From: Thomas Palmer (citizens' group representative)
79 Blue Hill Terrace St.
Milton, MA 02186
617-698-7759
ophis@comcast.net

Date: December 17, 2009 (via email/PDF)

Re: **DEP file No. 124-1043 Canton/Ponkapoag Golf Course Drainage and Irrigation Improvements**

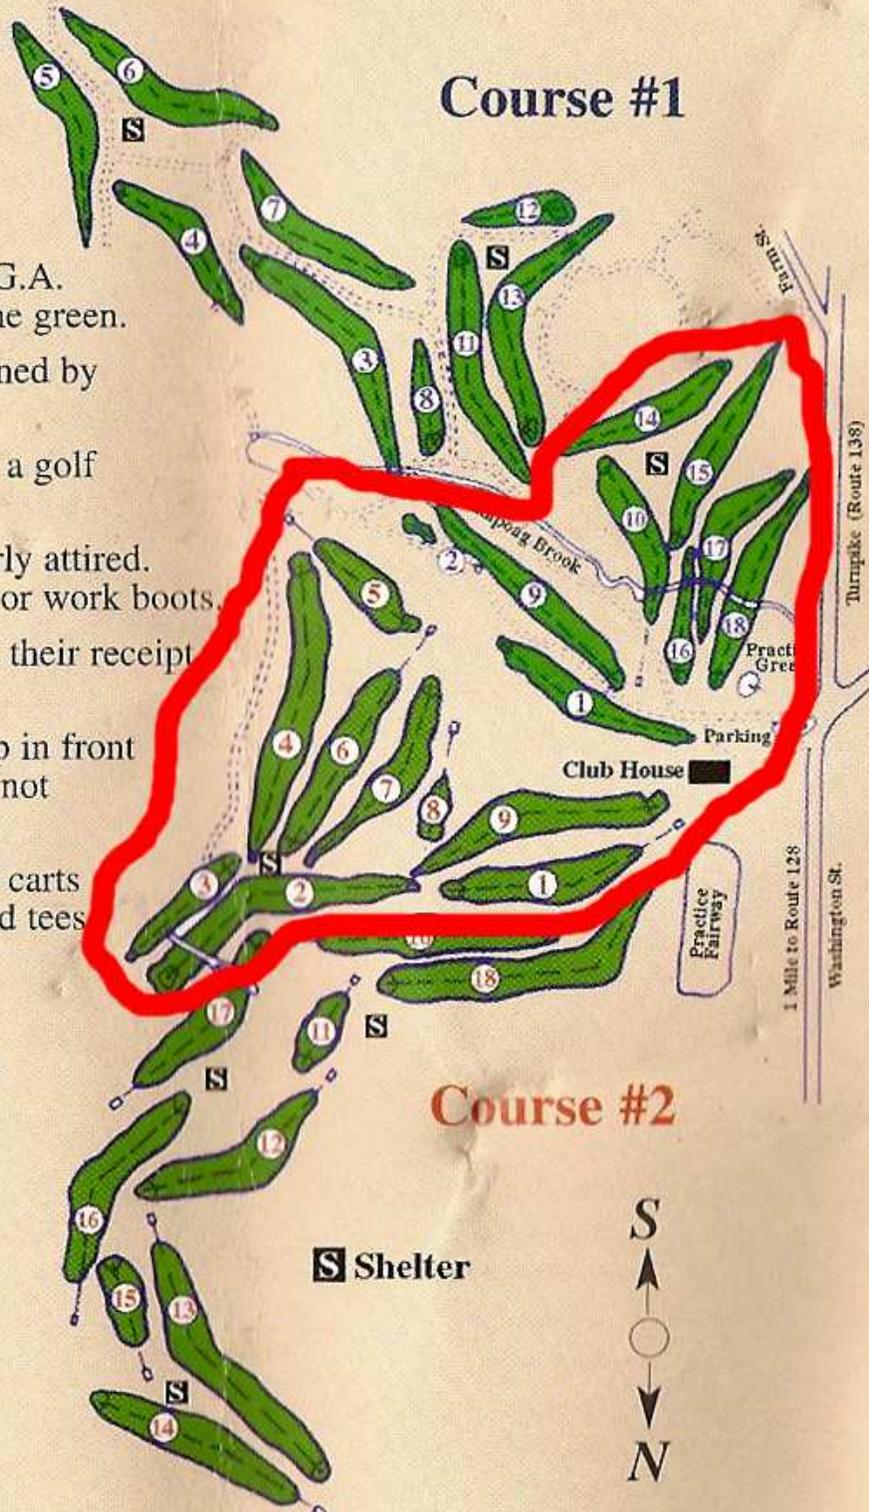
Attached to this letter is a map of the existing 36 holes with Ross's original 18 hole design, as described above, outlined in red. If DCR truly wants to restore Ross's vision, it should focus on the holes he created, and avoid refilling fairways 3, 7, and 8 of Course One, which were built in wetlands and are wetlands today.
